Southern Nuclear Operating Company
Vogtle Electric Generating Plant Units 3 and 4
Request for License Amendment and Exemption:
CA04 Structural Module ITAAC Dimensions Change (LAR-15-015)

Request for License Amendment Regarding
CA04 Structural Module ITAAC Dimension Change
(LAR-15-015)

Exemption Request:
CA04 Structural Module ITAAC Dimension Change (LAR-15-015)

Proposed Changes to the Licensing Basis Documents
(LAR-15-015)

Figure 1: Concrete Cross-Section between CA04 and CB65 (not to scale)

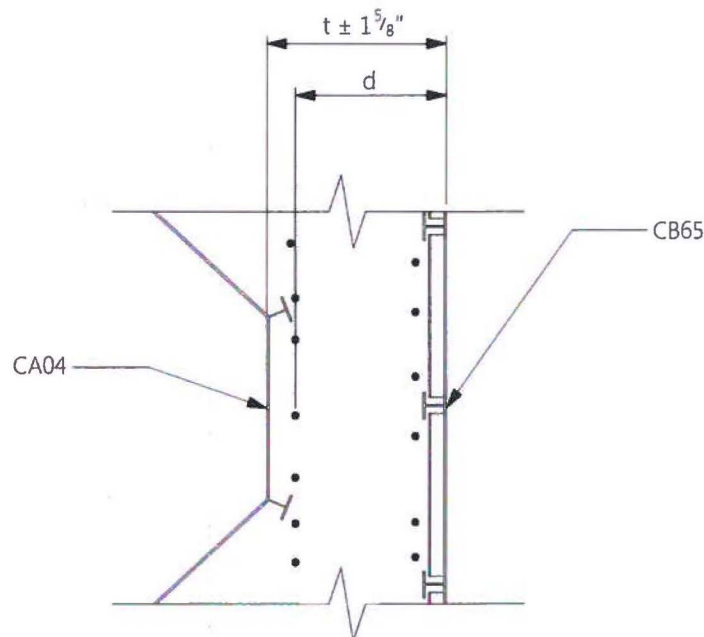
The proposed installation tolerance of $\pm 1\text{-}5/8"$ between the CA04/CB65 wall is greater than the $\pm 1"$ specified in ACI 349-01 Section 7.5.2.1 and the $+1\text{'}/-3/4"$ found in ACI 117. To determine the impact and the margin, an assessment was performed of the affected areas. Figure 1 depicts the CA04/CB65 cross-section and shows the d value which is the distance from the extreme compression fiber to the centroid of the rebar per ACI 349-01. The d value is the governing parameter for the design in regards of determining the rebar demand and spacing.

In Figure 1, the thickness of the wall and the proposed thickness tolerance change requested for the CA04/CB65 wall is shown. For evaluation of the impact and the margin of the wall design variation, the wall thickness and corresponding d value was set to $\pm 1\text{-}5/8"$, which is greater than ACI 117 tolerances on cross-sectional dimensions. As a result of the assessment, it was found that the minimum margin for vertical reinforcement is 47.9%, for horizontal reinforcement 54.8% and for shear 61.3%. Since the thickness of the wall also influences the d value, an assessment of the shear reinforcement spacing was performed which found the provided spacing sufficient.

To address these issues, it is proposed that the concrete thickness tolerance specified in COL Appendix C and associated plant-specific DCD Tier 1 Table 3.3-1 for both the CA04/CA01 and CA04/CB65 walls be increased to $\pm 1\text{-}5/8"$ to accommodate the combined fabrication and assembly tolerance plus the installation tolerance of the adjacent modules by adding an exception to Note 2 and adding one note to Table 3.3-1. Note 2 is proposed to be modified to state that the tolerance is as stated in the note except as noted elsewhere.

The added note to Table 3.3-1, labeled Note 10, is footnoted to the concrete thickness in the four affected walls, the first four items in Table 3.3-1. This note specifies that this concrete thickness has a construction tolerance of $\pm 1\text{-}5/8"$.
